From: Bastek, Brian
Sent: Tuesday, August 4, 2015 9:12 AM
To: Luetscher, Greg
Subject: FW: Grenada VI Investigation- Work Plan Prepared by Arcadis for Grenada Manufacturing, LLC
Attachments: 0531 001.pdf

SUBJECT: Review of Interim Measures Work Plan
Vapor Intrusion Assessment
Grenada Manufacturing LLC
Grenada, Mississippi

Per your request, I have reviewed the Interim Measures Work Plan for **Grenada Manufacturing**, located in Grenada, MS. My review has focused on the human health risk aspects of the document prepared by ARCADIS, as it pertains to vapor intrusion sampling.

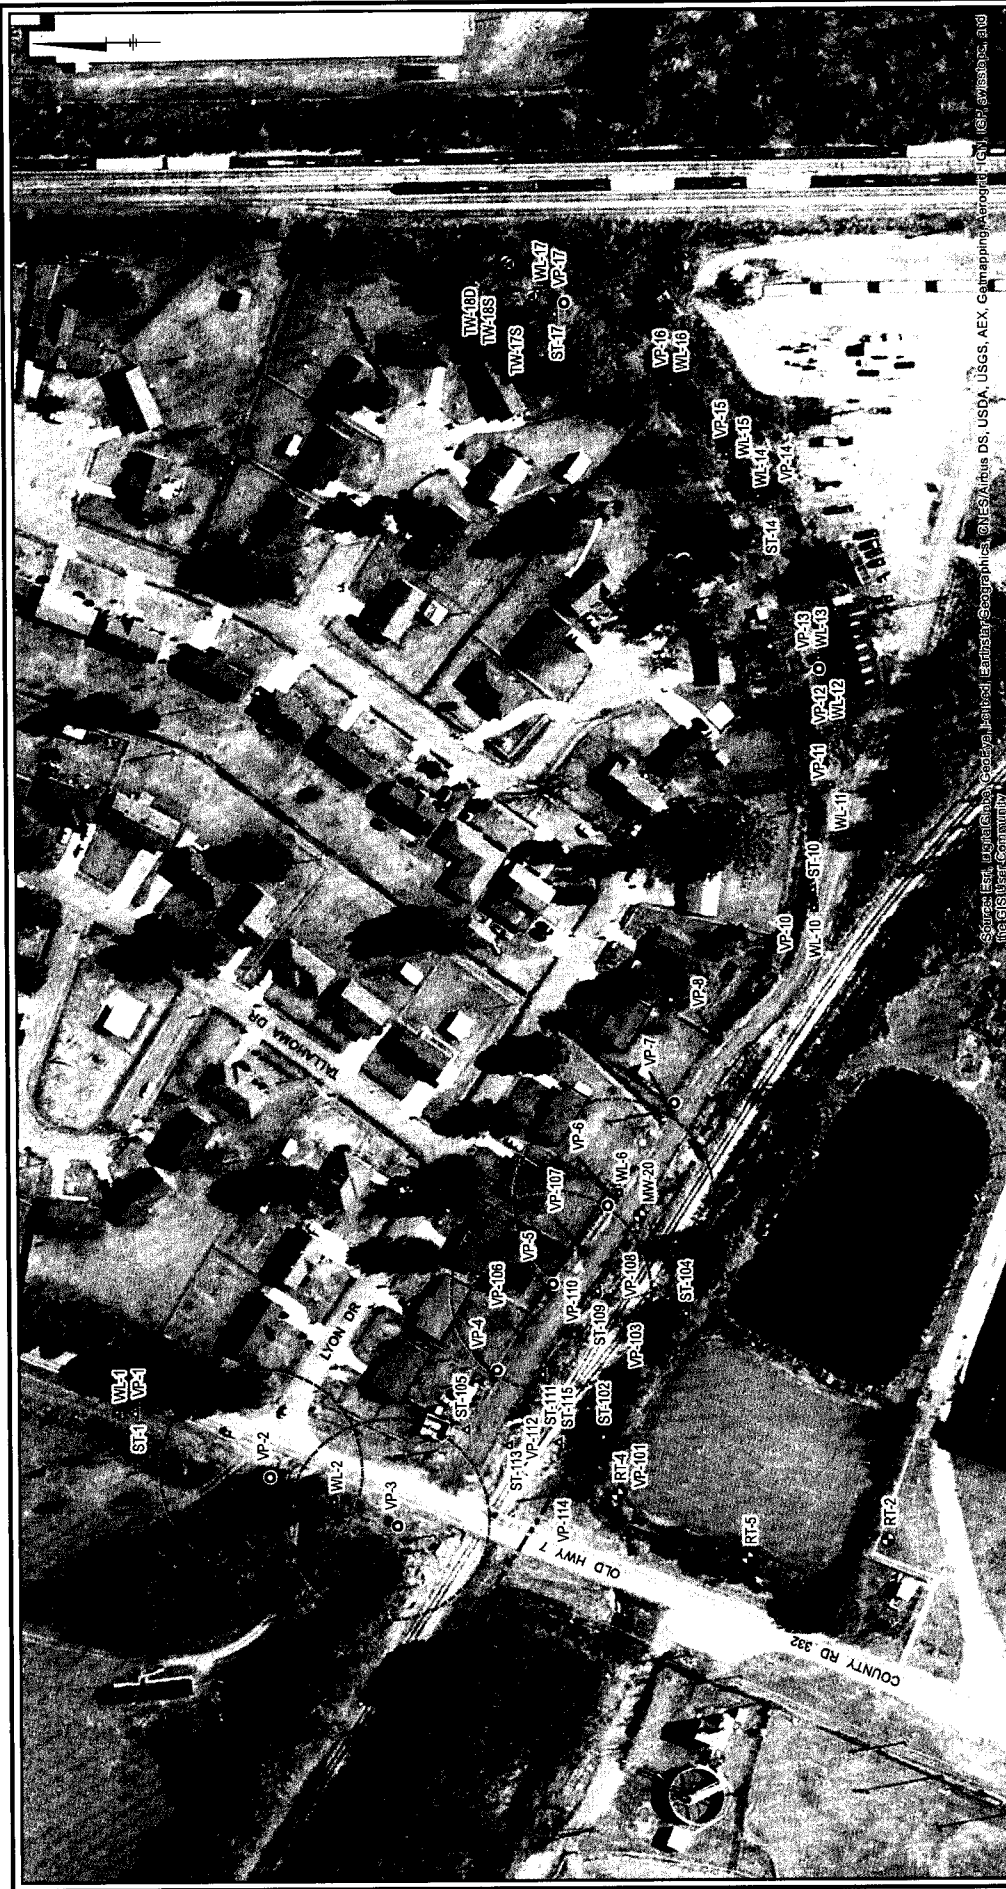
1. **Scope of Work, p.2.** The author has made several statements in the workplan that "If the evaluation indicates that the VI pathway is incomplete, additional evaluation is not warranted". EPA recommends that any determination that the vapor intrusion pathway is incomplete be supported by site-specific evidence to

5. **Data Evaluation and Reporting, p. 7.** The author indicated that data would be evaluated against EPA's OSWER indoor air background studies report (USEPA, 2011a). EPA Region 4 requests that the author revise the text and discuss the background report as an uncertainty. Specifically, address the limitations of the report and its interpretation recognizing that no locations from the southeastern U.S. were represented in the study and the findings may not be generalizable to Grenada, Mississippi. Although published background levels are helpful in interpreting indoor and outdoor air data, site-specific background data are preferred in allowing for quantitative comparisons and are one tool used in a multiple-lines-of-evidence approach to data evaluation and decision-making.

FIGURE 2-1

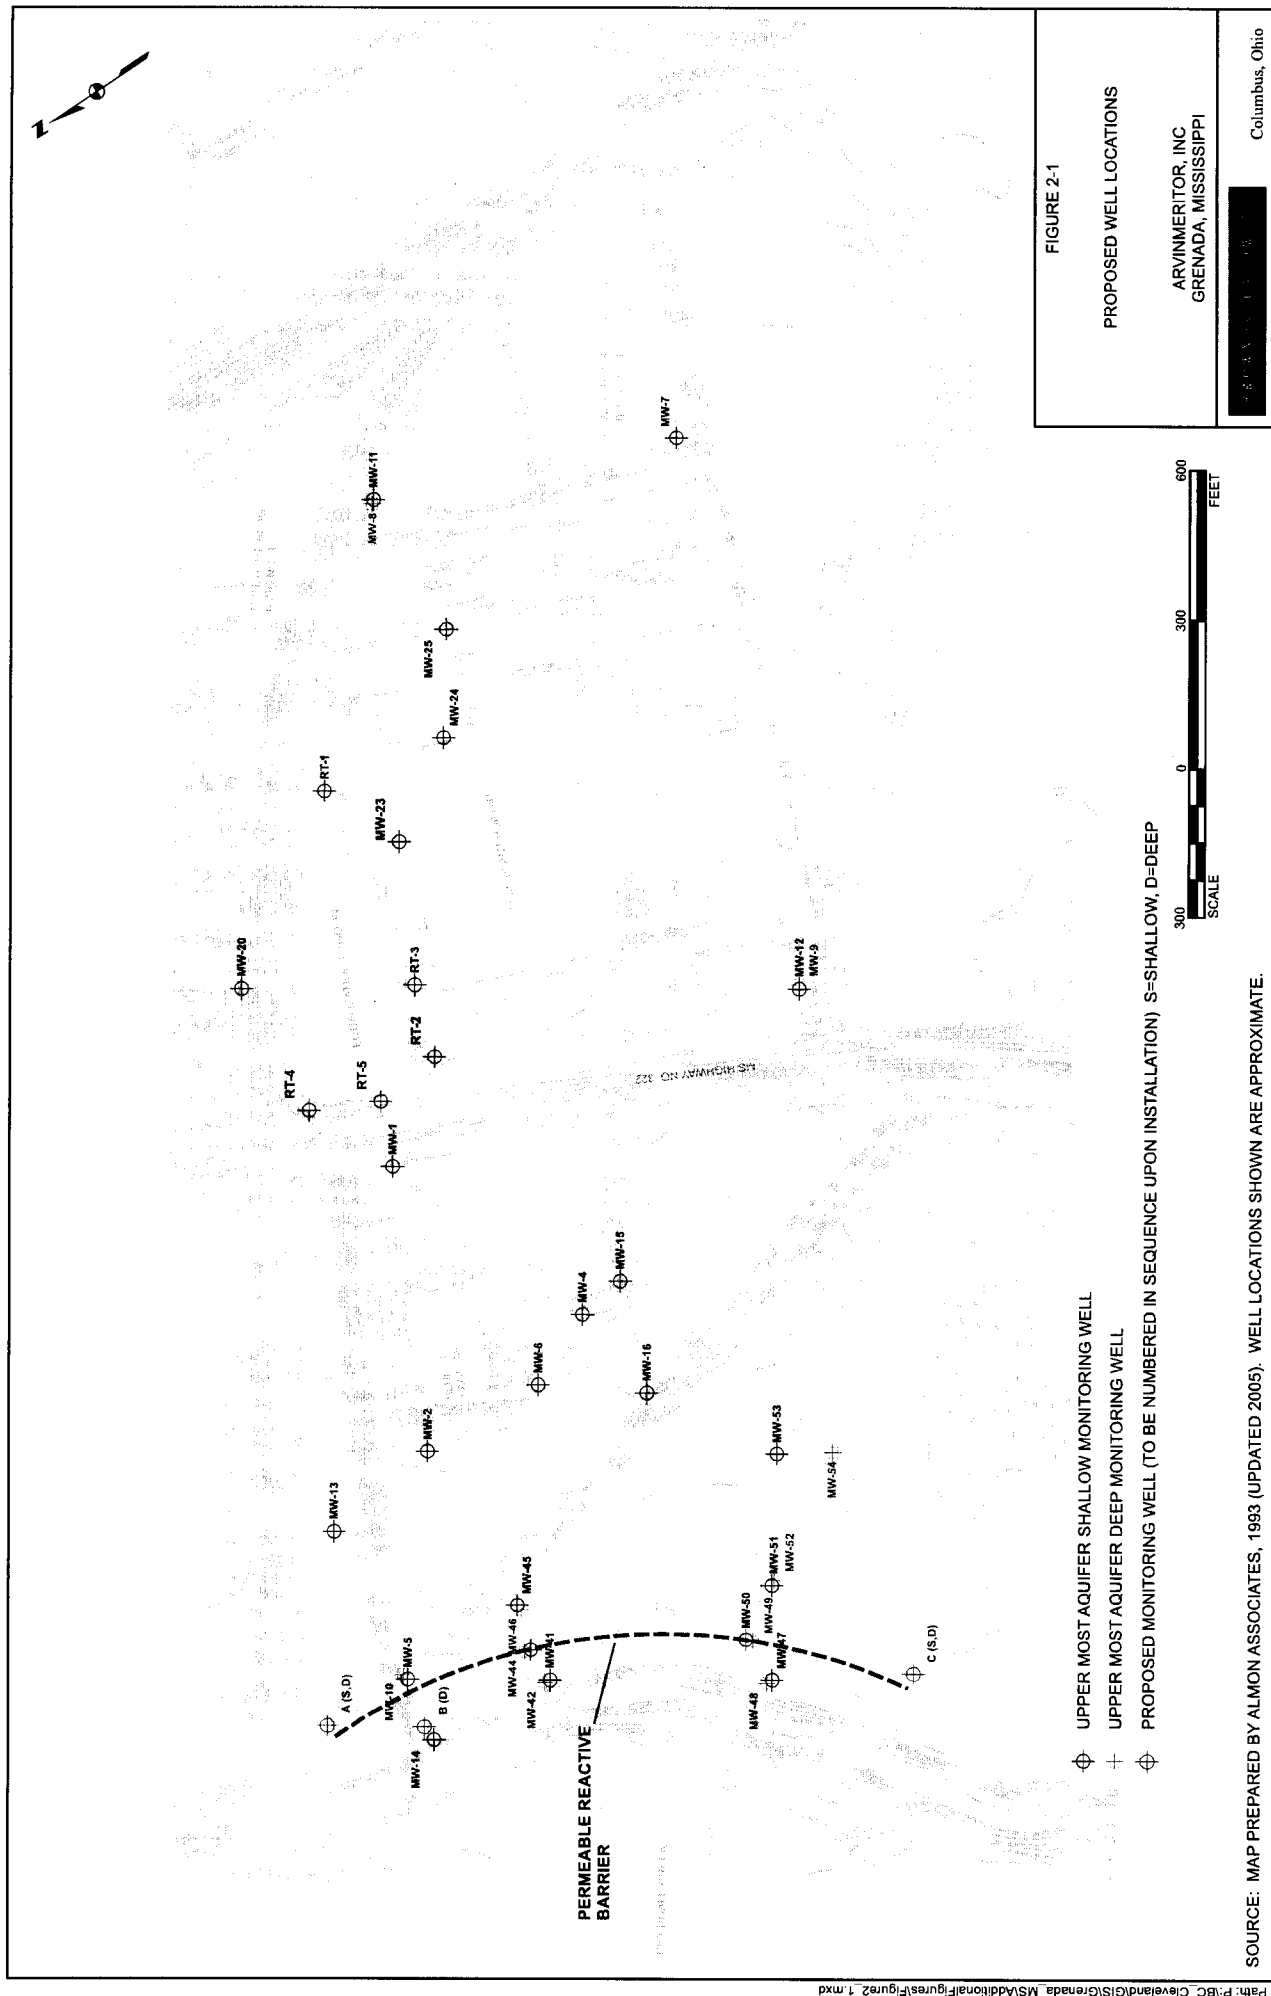
Two wells will be installed at both the northern and southern ends of the PRB at locations A and C shown on Figure 2-1. The two locations (A and C) are approximately 10 feet back from each end of the wall and 10 feet upgradient of the wall. In addition, a deep well will be installed near the location of MW-14 and is designated as Well B on Figure 2-1. Minor field adjustment of these locations may be required based on the conditions encountered in the field. The letters indicated on Figure 2-1 are included as place holders for the permanent well names, which will be designated at the time of well installation based on the existing sequence of well numbers at the Site and the order in which the wells are installed.

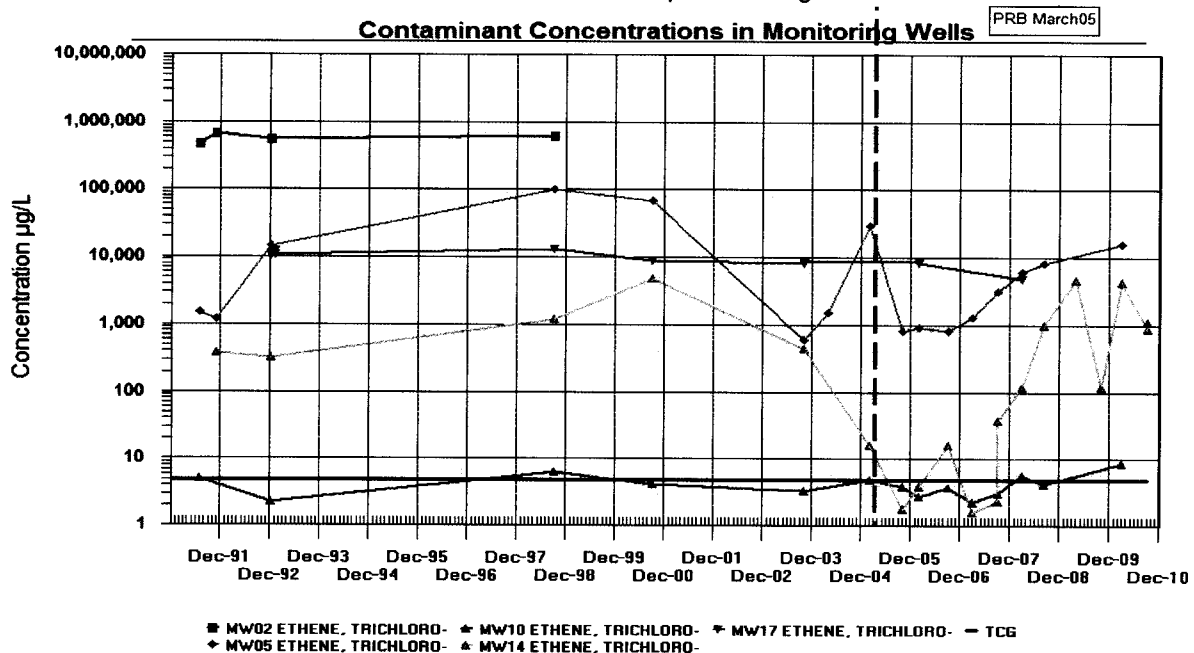
The contaminant concentration trends in wells MW2, 5, 14, 17 and SW12 have not shown a clear and meaningful decrease in TCE concentrations during the history of the sampling program. The monitoring wells in this highly contaminated portion of the plume are far apart, and the increasing TCE concentrations on both sides of the PRB beginning shortly after the installation of the PRB suggest the wall may have already failed in this area (see graph below). Note the stability of TCE concentrations in MW2 and 17; little progress toward cleanup is apparent in these wells. Note MW5 and MW14 both have increasing TCE concentrations since the PRB was installed and that TCE concentrations in MW14 after the wall installation are as high as ever. Note also that TCE concentrations in MW10 are higher than ever before. MW10 is a shallow well near what should be the edge of the plume, so the increasing concentration in this well, though small, are surprising. Note also that there no deep well near the MW14 location. Selected data from Table 3-2 has been used to update this figure.

Lower Aquifer TCE Concentration Map 2004 – Prior to PRB Installation

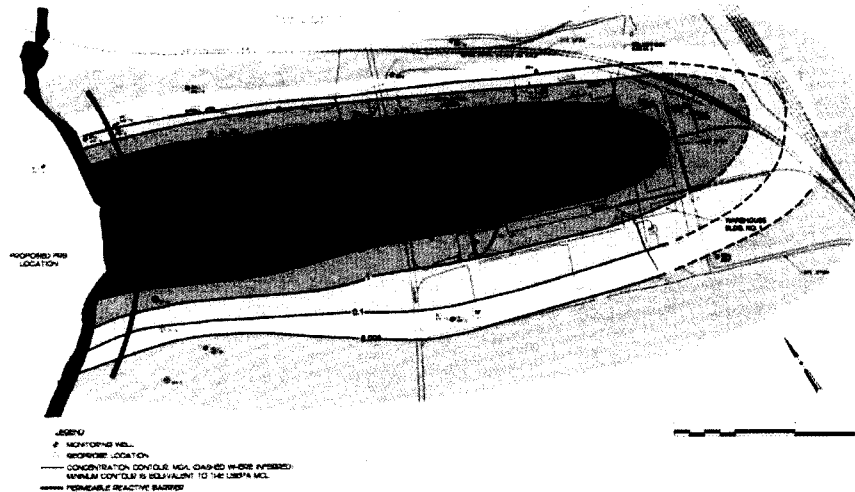
In the map above, all of the wells plotted in the trend graph above (MW2, 5, 10, 14 and 17) are located on the northern edge of the plume. Up gradient from the PRB, increasing TCE concentrations in this area particularly at MW5 and MW10 may mean the plume is trying to move around the north end of the wall.
